To: Snohomish County Council  
From: Tom McCormick  
Date: September 7, 2018  
Re: OHWM Misrepresentations — Memorandum Opposing BSRE's Appeal

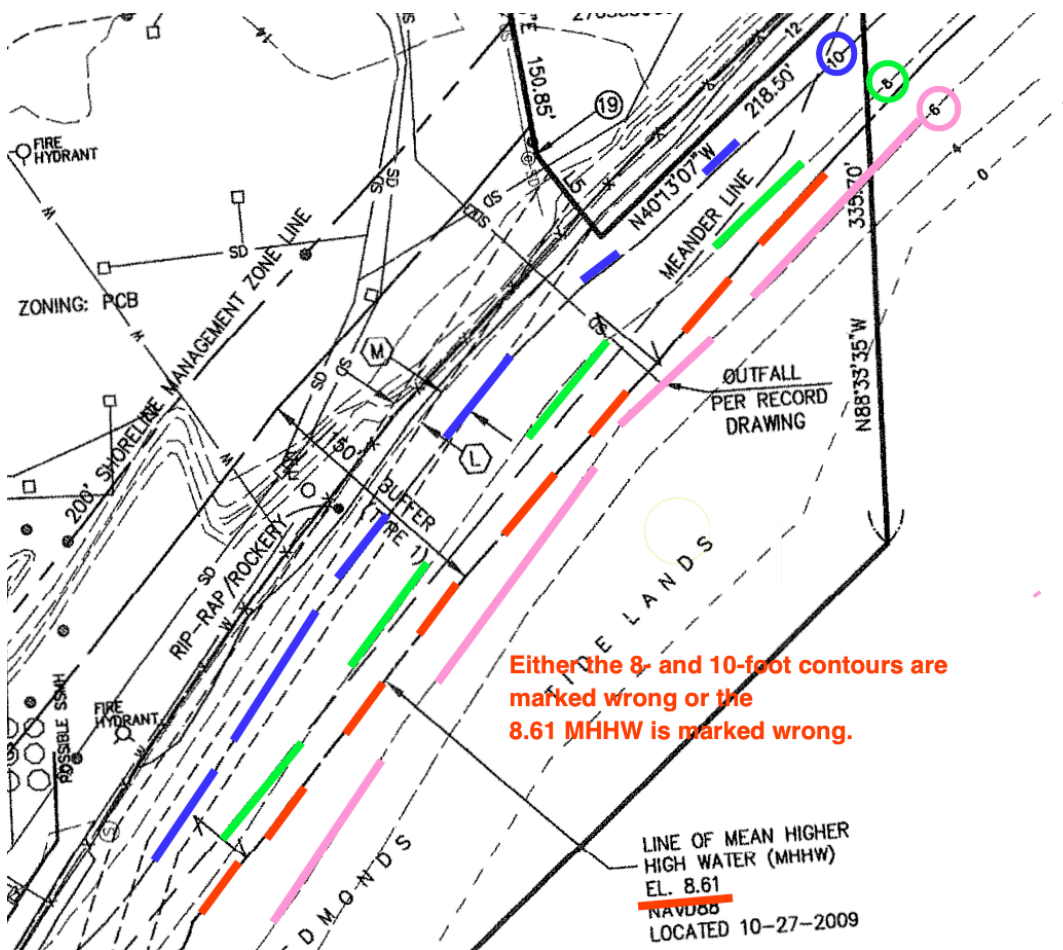
Below is a photo taken by a Department of Ecology representative on June 26, 2018, that I received pursuant to a public records request. Notice the vegetation, and three stakes identifying the OHWM at the southern portion of Point Wells (I added the circles).

Due to the presence of vegetation at Point Wells, the OHWM is easy to find (see the photo on page 2 above). Since at least 2010, BSRE has known that there is vegetation on large portions of the shoreline.<sup>17</sup>

The line of stakes in the photo (identifying the OHWM) is quite close to the fence line on the southern portion of the site. The line of stakes is much closer to the fence than is the March 2018 OHWM line depicted on some of BSRE's site plans,<sup>35</sup> and much closer to the fence
